Clean and Healthy Ocean Integrated Program (CHO-IP)

Review PIF and Make a recommendation

GEF-8 PROJECT IDENTIFICATION FORM (PIF) REVIEW SHEET

Figure 4: Governance Framework Diagram

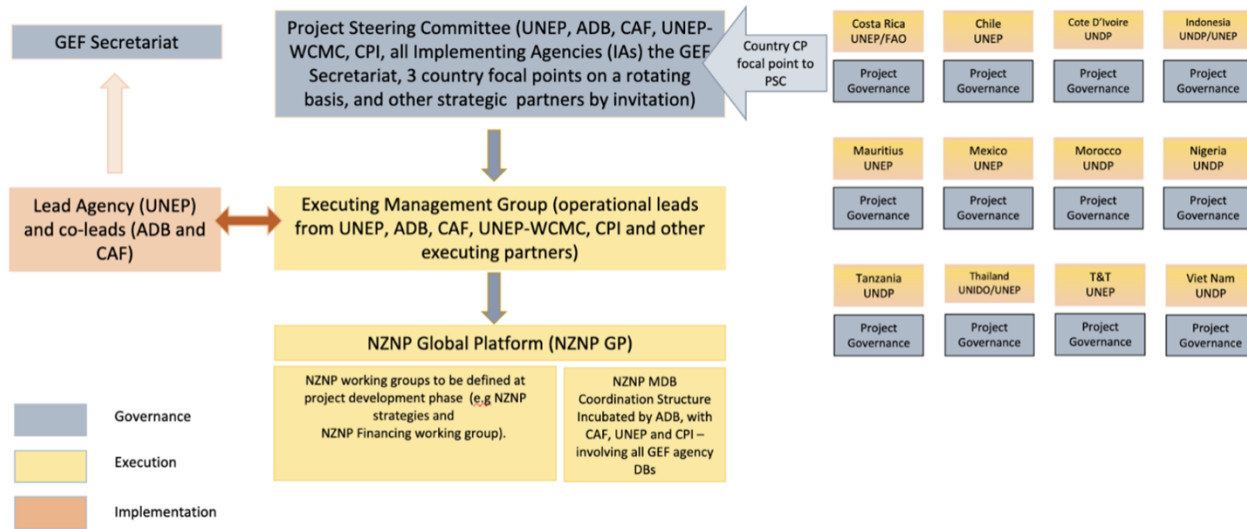
(i) Please include an overall program governance diagram linking all the key groups, their functions and coordination mechanisms:

(a) (i) Addressed. The governance framework diagram is duplicated. Please remove one.

a) i. Duplicated figure removed.

i) an overall program governance diagram linking all the key groups, their functions, and coordination mechanisms was added.
